Subject **On-Campus Traffic Control Signing – Ox Ridge Elementary School, 395
Mansfield Avenue, Darien, Connecticut**

**ON - CAMPUS ADDITIONAL
TRAFFIC CONTROL SIGNING**

**OX RIDGE
ELEMENTARY SCHOOL
395 Mansfield Ave. - Darlen, CT**

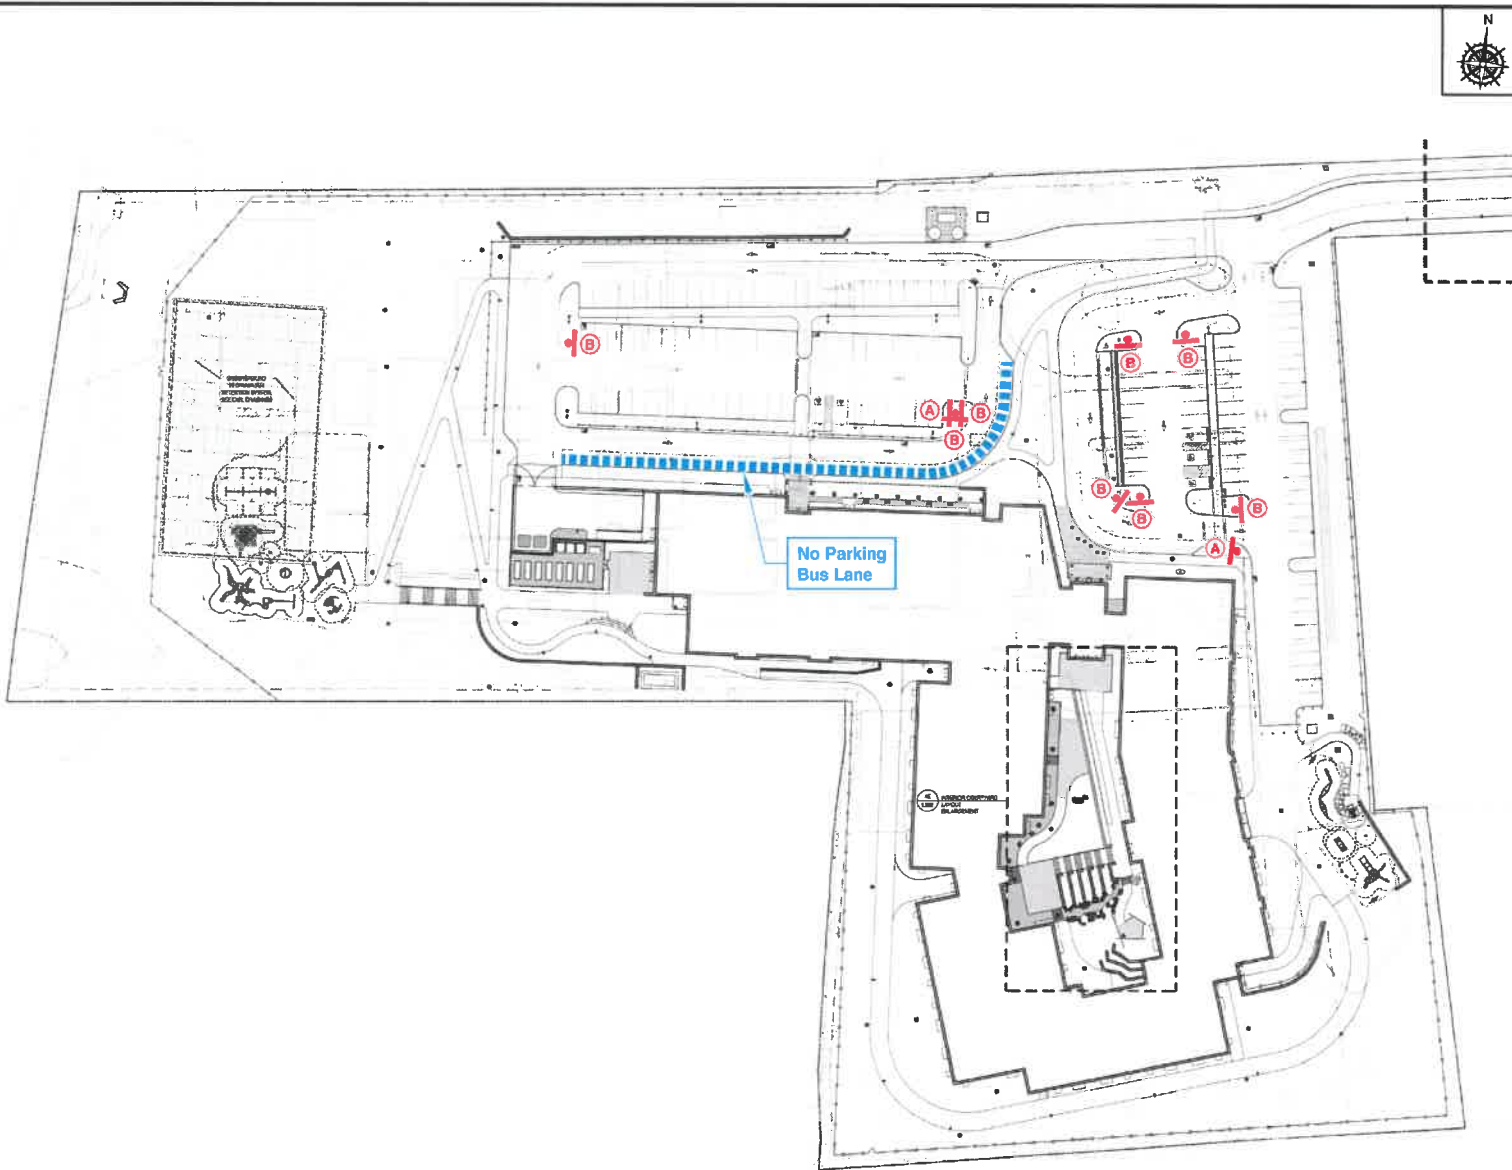
As a follow up to our May 4, 2020 Parking Evaluation letter, the attached plan is an overlay to the Applicant's Site Plan and shows our recommendations for additional traffic control signs.

The Applicant has provided a Traffic Control Signing Plan and the attached plan is our recommended additional signs, which are limited to STOP and DO NOT ENTER signs. We also recommend that the Town consider an appropriate sign for NO PARKING IN BUS LANE and may also include a time limit for this restriction.

We have not recommended any NO PARKING signs in the parent drop-off/pick-up lane, since this may be used for short-term parking during the School day.
